Staff Report

Infill Housing Design Review Committee

File Number: 4-I-21-IH

Location: 1219 Texas Ave. **Parcel ID** 81 I C 017
Zoning: RN-2 (Single-Family Residential Neighborhood)
District: Lonsdale Infill Housing Overlay District

PLOT PLAN FOR LOT 182, ROSEDALE ADDITION TO THE CITY OF KNOXVILLE

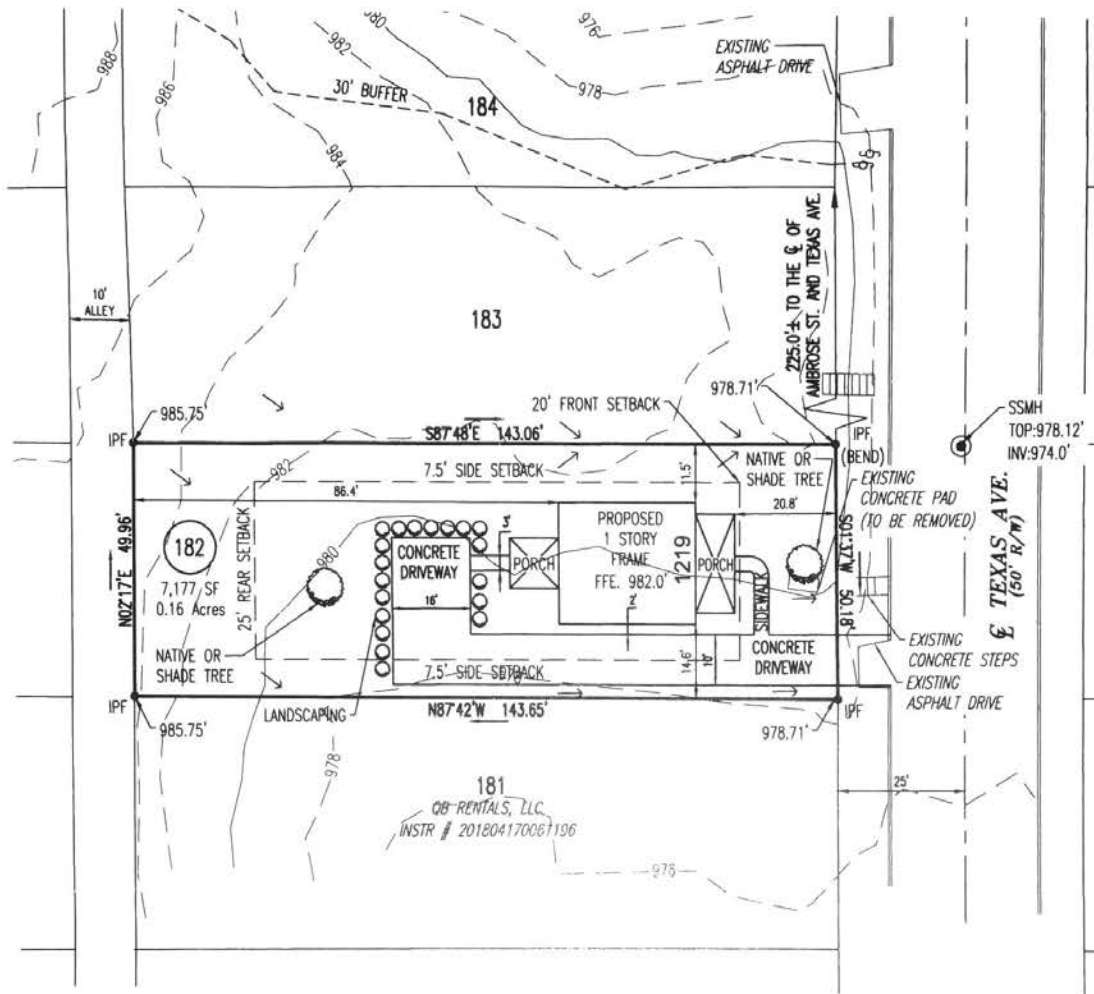
1. The house is proposed with a front setback of 20.8' from the front porch to the property line, and 28.8' to the primary residence. The proposed new construction at adjacent 1215 Texas Avenue will reflect the same setback pattern. The proposed front setback will maintain front yard spaces consistent with the rest of the block.

6. The applicant proposes to extend the driveway off Texas Avenue. While guidelines encourage using operable alleys whenever possible, the alley on the 1200 block of Texas Avenue stops behind 1227 Texas Ave. City Engineering has confirmed the alley is not operable behind 1227 Texas Ave, so access will have to extend off Texas Avenue. The proposed parking meets City Engineering requirements and the Infill Housing guidelines.

7. The site plan shows native shade trees in the façade and rear yards, which meets design guidelines for landscaping. Landscaping is shown to surround the parking pad in the rear.

8. A 10' by 10' rear porch is shown on the site plan but not elevation drawings.
 9. The proposed design is identical to 1215 Texas Avenue (4-H-21-IH) and differentiation is necessary between the two designs.
-

- 1) Parking to meet City Engineering standards;
- 2) Use horizontal lap siding instead of Dutch lap or flush panel siding to reflect historic context;
- 3) Use a foundation height and cladding materials comparable to historic houses on the block;
- 4) Incorporate a zero-step entry and meet City Homemaker accessibility requirements;
- 5) Introduce a variation in the design between 1215 Texas Avenue (4-H-21-IH) and 1219 Texas Avenue, with approval by staff.

EXTERIOR
 ELEVATIONS
 WALL
 SECTION

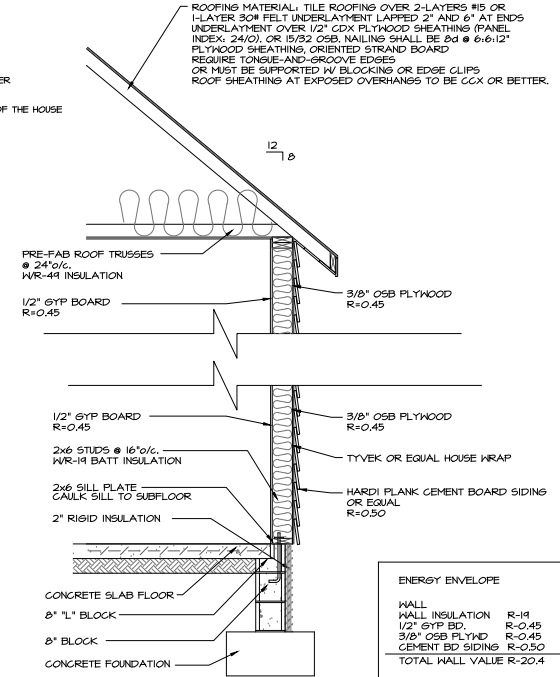
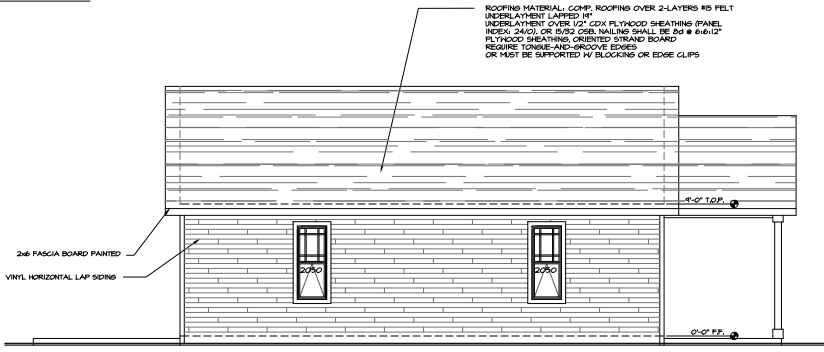
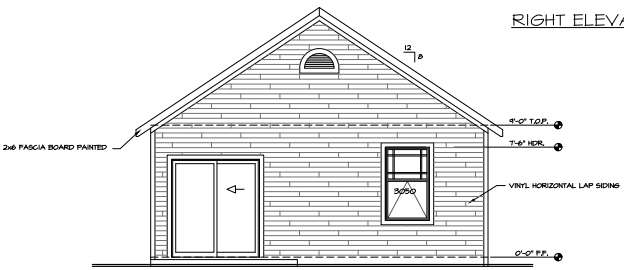
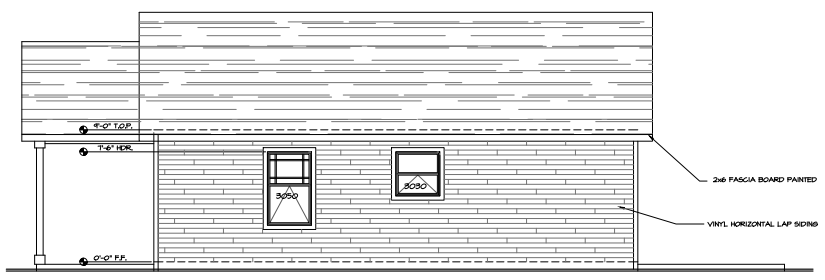
2. The 1200 block of Texas Avenue features a variety of simple housing styles, including several Queen Anne cottages, Minimal Traditionals, and some contemporary infill construction. A one-story, modestly-sized house is somewhat smaller in scale than other houses on the block. A 24' wide façade is smaller than original houses on the block. Foundation height should be verified to reflect heights of original houses in the surrounding blocks.

3. The 8' deep front porch meets the design guidelines for size and placement.
 4. Guidelines recommend window and door styles to be comparable to original or historic houses on the block; the revised elevation drawings incorporate double-hung windows with sufficient transparency for a small house. Applicant has noted the final window selections will be one-over-one instead of the Prairie-style muntins shown on the elevation drawings.

5. The proposed roof has an 8/12 pitch, which is sufficiently steep to meet the design guidelines. Horizontal siding also meets the design guidelines; applicant should select a lap siding instead of Dutch lap or flush panel siding to reflect historic context.
